JAN 17 1995

Your January 4 letter to Mr. William A. Weseman requested the Federal Highway Administration to review test data on your Guardrail Safety Barrier to determine its acceptability for use as a temporary longitudinal barrier on highway projects on the National Highway System.

Geometric and Roadside Design Acceptance Letter No. B-30

GUARDIAN
350 HIGHWAY KIT™

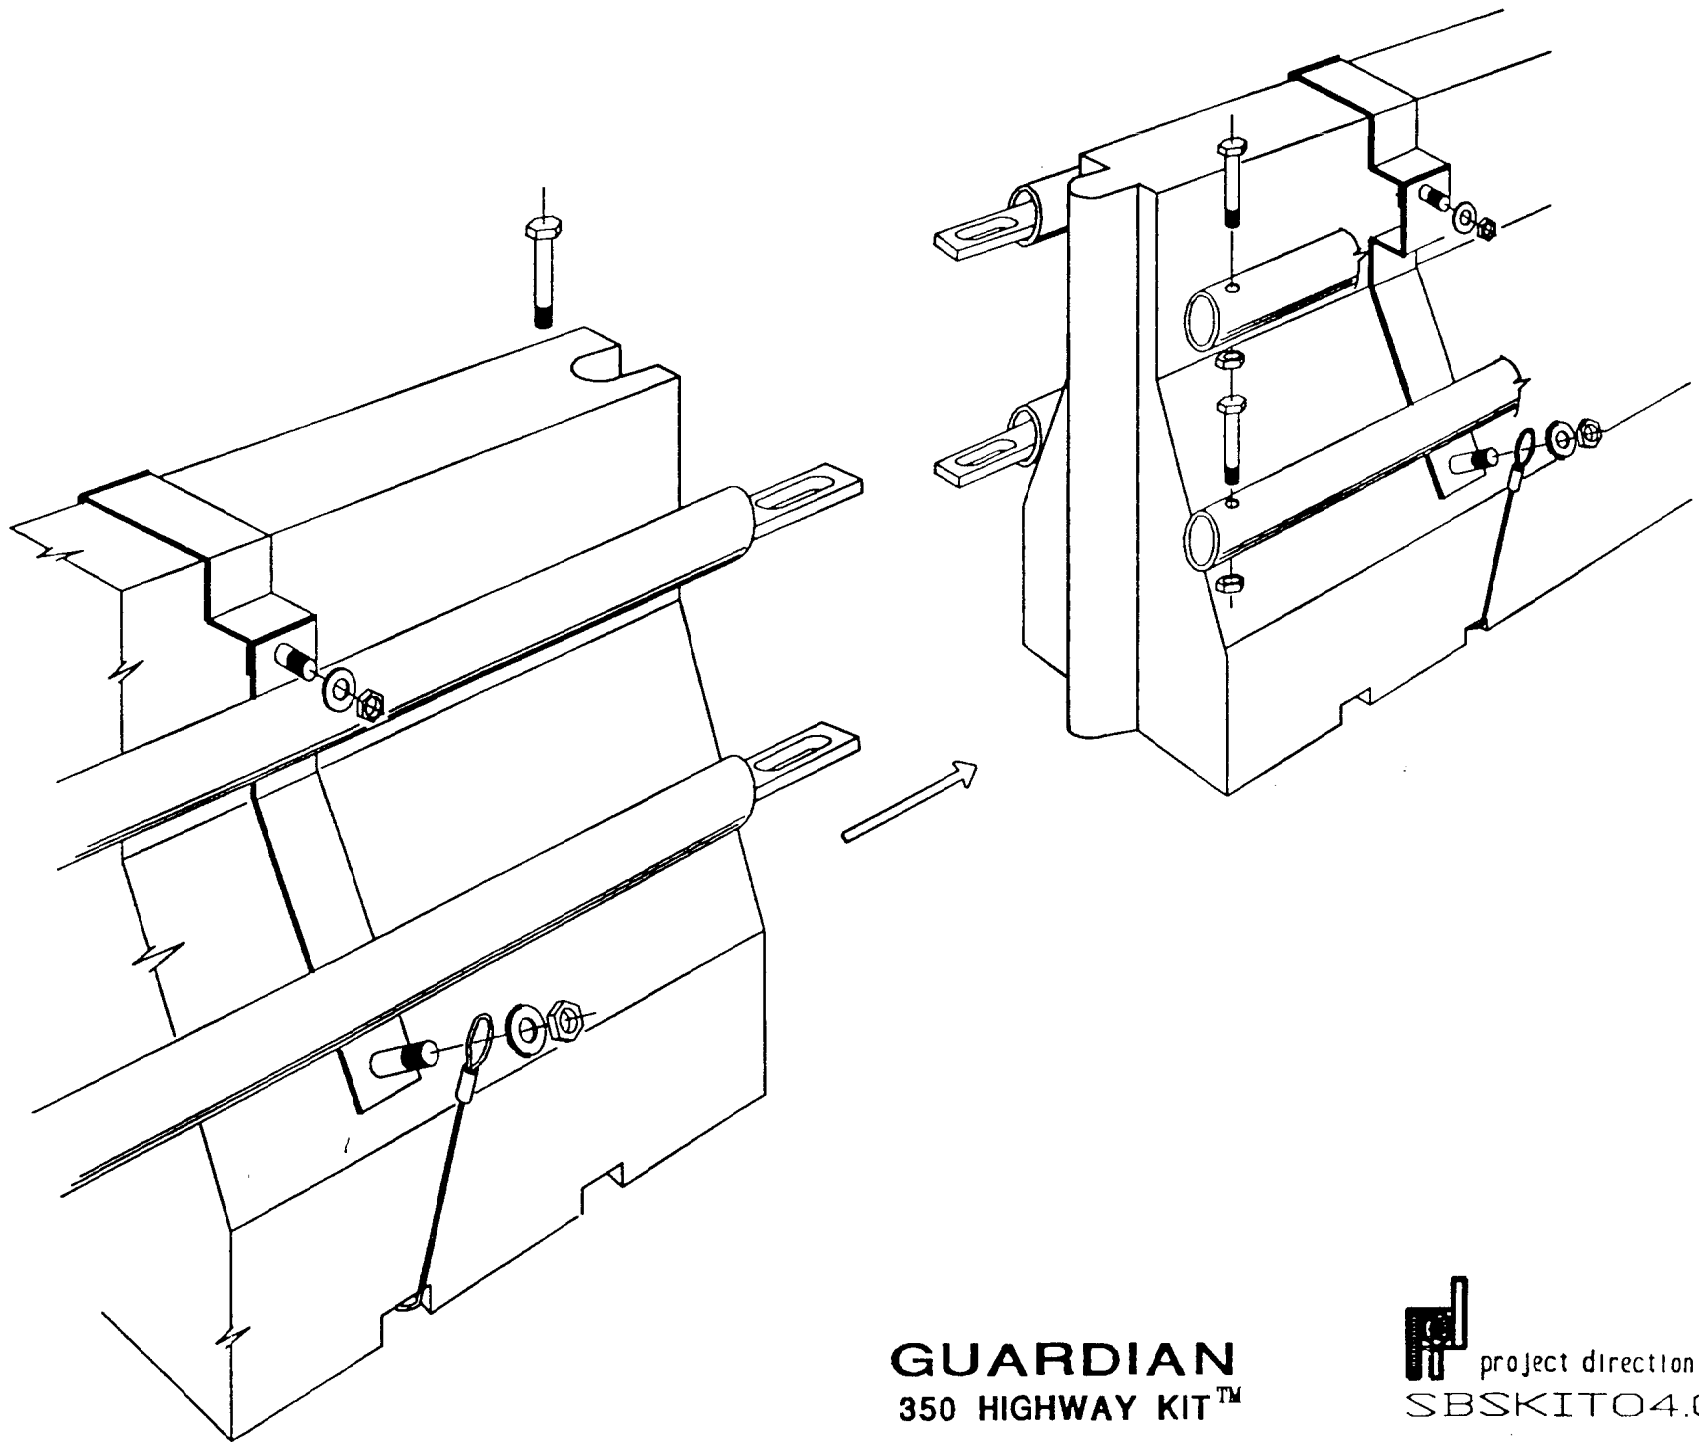
Individual barrier segments are 1830-mm long by 1070-mm high low-density polyethylene water-filled containers. An exterior steel (ASTM A-36) frame, consisting of 7.9 mm by 76.2 mm straps, 50.8 mm schedule 40 pipes and 6.4 mm cables, is mounted on each segment. Connections between adjacent segments are made with 9.5 mm x 44.5 mm x 203 mm bars welded to the inside of the pipes on one end and slotted on the other for a bolted connection. The test installation consisted of 33 such segments for a total barrier length of 60.4 m. A schematic drawing and material specifications for the Guardian are enclosed.

Based on the above results and the post-crash vehicle trajectories, we concur that the Guardian barrier satisfactorily meets the criteria for a TL-2 traffic barrier and find it acceptable for use on Federal projects when requested by a State highway agency.

Since the Guardian system was evaluated at TL-2, it is appropriate for use at locations where impact speeds and angles are not expected to exceed test conditions. However, the crash tests indicate that the Guardian may have capacity beyond test level 2 based on the stable redirection of the both vehicles at the 70 km/h impact speeds, relatively slight deflection of the barrier, and low occupant impact velocities and ridedown acceleration. Accordingly, you may wish to test this barrier to TL-3. You may also wish to identify an appropriate end treatment for the Guardian. At present, the Guardian would need to be flared an appropriate distance from approaching traffic or be shielded with a conventional work zone crash cushion.
